DATA QUALITY ACT CHALLENGE AND REQUEST FOR CORRECTION
TO THE ARMY CORPS OF ENGINEERS

Pursuant to the Data Quality Act of 2000's Section (b)(2)(B), the U.S. Office of Management and Budget (OMB) *Guidelines for Ensuring and Maximizing the Quality, Objectivity, Utility, and Integrity of Information Disseminated by Federal Agencies*, and Section 3.3.4 of Attachment 1 of the Deputy Secretary of Defense's Memorandum dated February 10, 2003, *Ensuring Quality of Information Disseminated to the Public by the Department of Defense*, I, Madeleine Fortin, a private citizen, hereby challenge the information, data, analyses, and conclusions drawn in the document titled *SUPPLEMENTAL ENVIRONMENTAL IMPACT STATEMENT for the CENTRAL AND SOUTHERN FLORIDA PROJECT, MODIFIED WATER DELIVERIES TO EVERGLADES NATIONAL PARK, FLORIDA, 8.5 Square Mile Area, Volumes 1, 2, and 3* published July 2000 by the U.S. Army Corps of Engineers, Jacksonville District.

Model Hydrographs from Weekly Average Groundwater Stage at Cell
19213 FIGURE 63

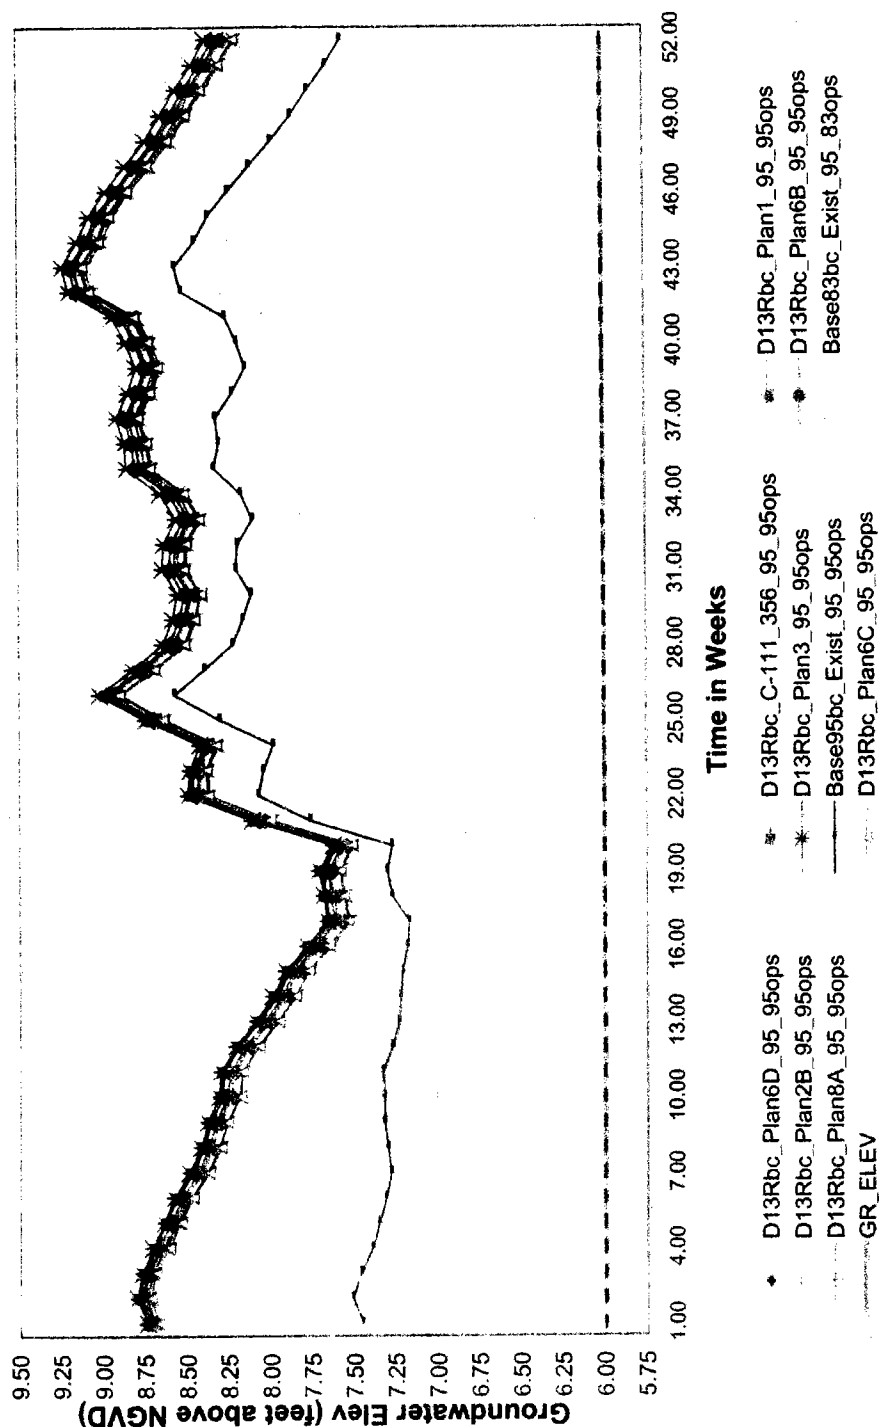
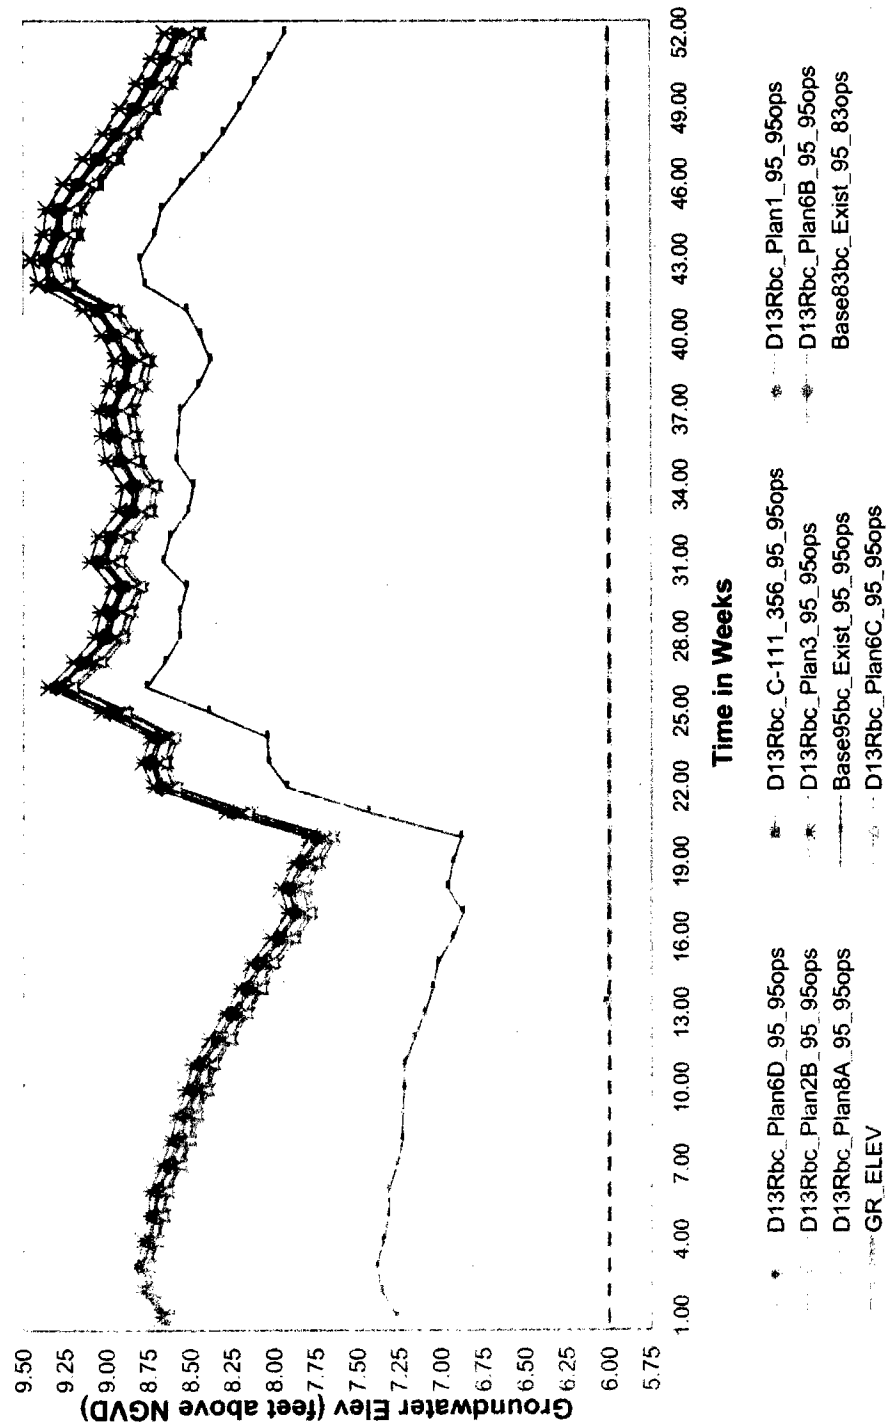
Computer generated hydrographs published in the SEIS show ground water levels from the Corps original project, labeled as "Plan 1," (which protected the entire 8.5 SMA community) as being virtually identical to ground water levels generated by the Corps chosen project 6D in cells 19213 and 19990, in Northeast Shark River Slough (NESRS). (Appendix 3 pg.54 & 56)

Model Hydrographs from Weekly Average Groundwater Stage at Cell
20925 FIGURE 42

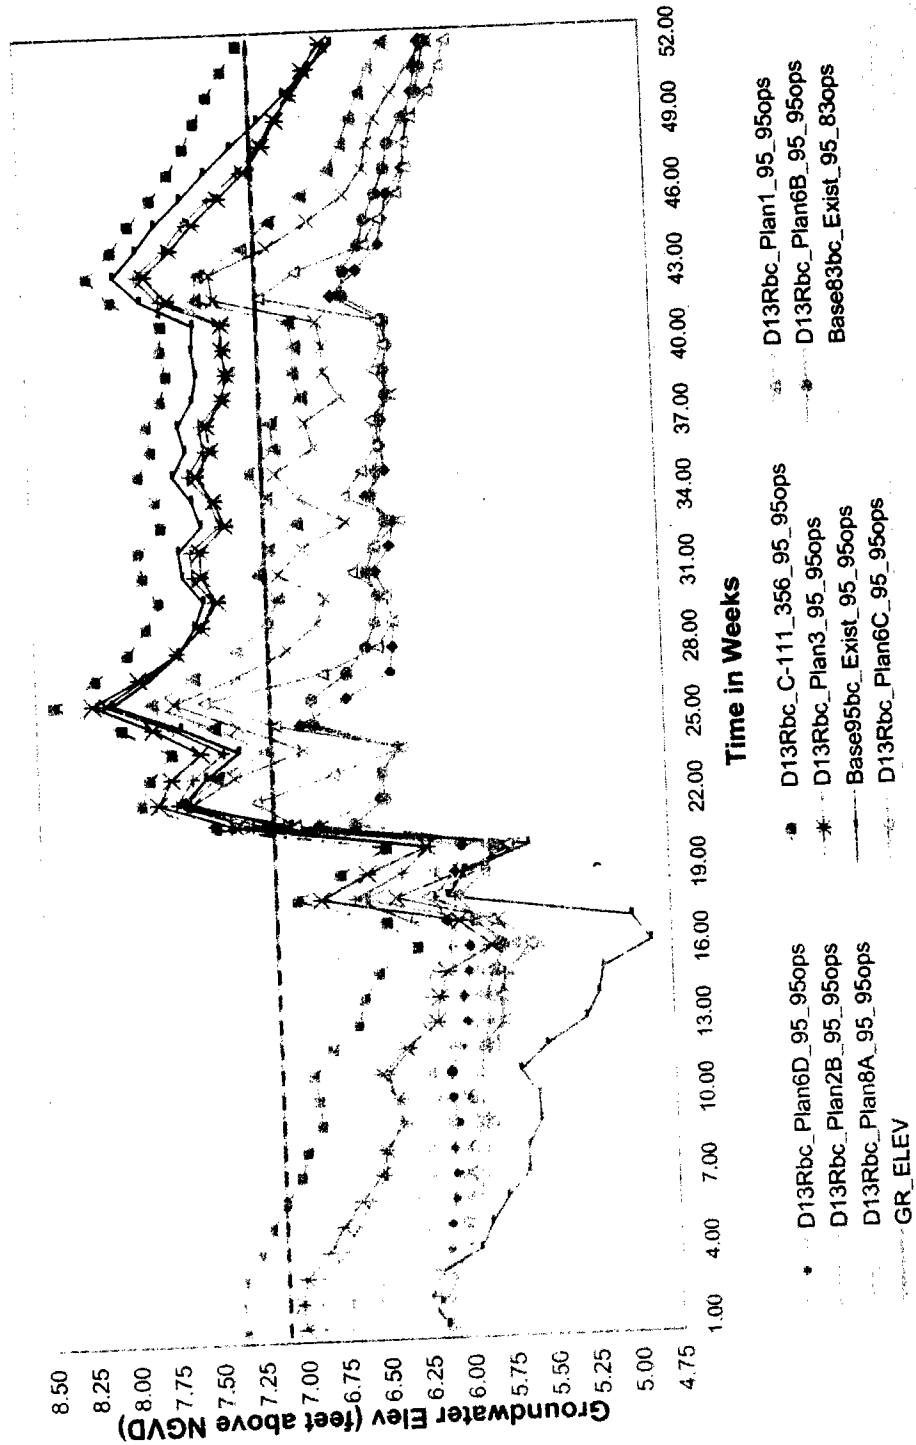
Hydrographs published in the SEIS show that in cell 20925, within the protected portion of the 8.5 SMA community, Base83 conditions will result in water above the surface of the ground from week 22 until week 48, or 26 uninterrupted weeks of water above the surface of the ground, east of the protective canal and within the protected portion of the community during a wet year. This same hydrograph shows water levels provided by alternative 6D as lower than Base83, but the Corps has continued to maintain that they will only be providing the community with Base83 conditions. (Appendix 3, pg. 58)
